## DAYCO AFTERMARKET TECHNICAL INFORMATION

**Subject:** 94825 TIMING BELT  
INCLUDES KTBA145 & KTBA150 TIMING KITS

**T00014**

**Holden Vectra X25XE, Y26SE, Z32SER**  
**Holden Calibra C25XE**  
**Saab 900, 9000, 9-5 B258, B308, B308E**

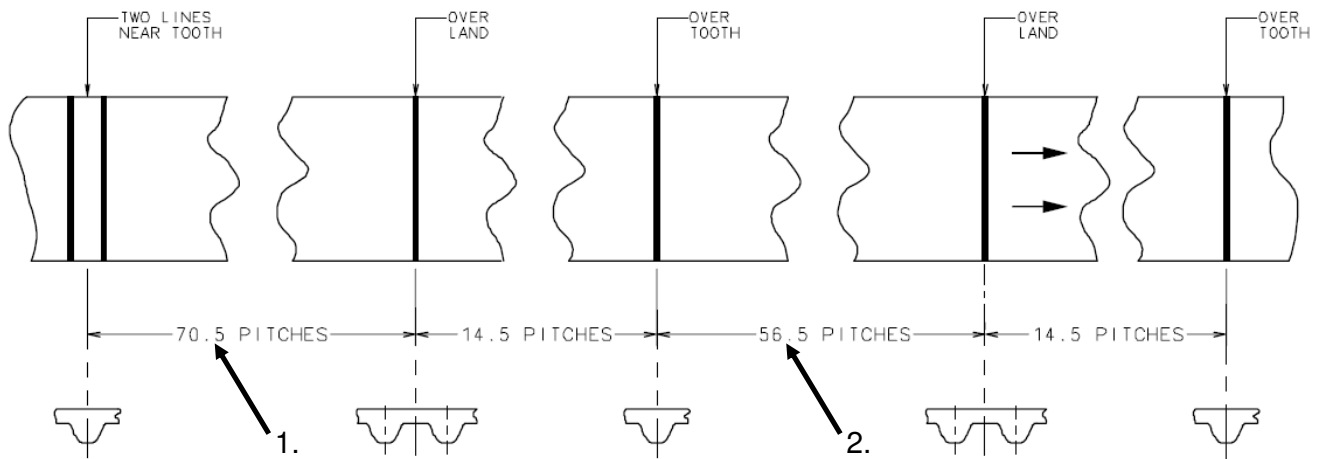
As a guide, refer below for the actual timing mark pitch spacing on the 94825 timing belt

In the vehicle applications where these marks may not be relevant, the following should be used as a guide:

1. Crank reference (double lines) to next mark: replace "70.5 pitches" with "69.5 pitches"
2. Intake bank #1 mark (left) to inlet bank #2 mark (right): replace "56.5 pitches" with "61.5 pitches"
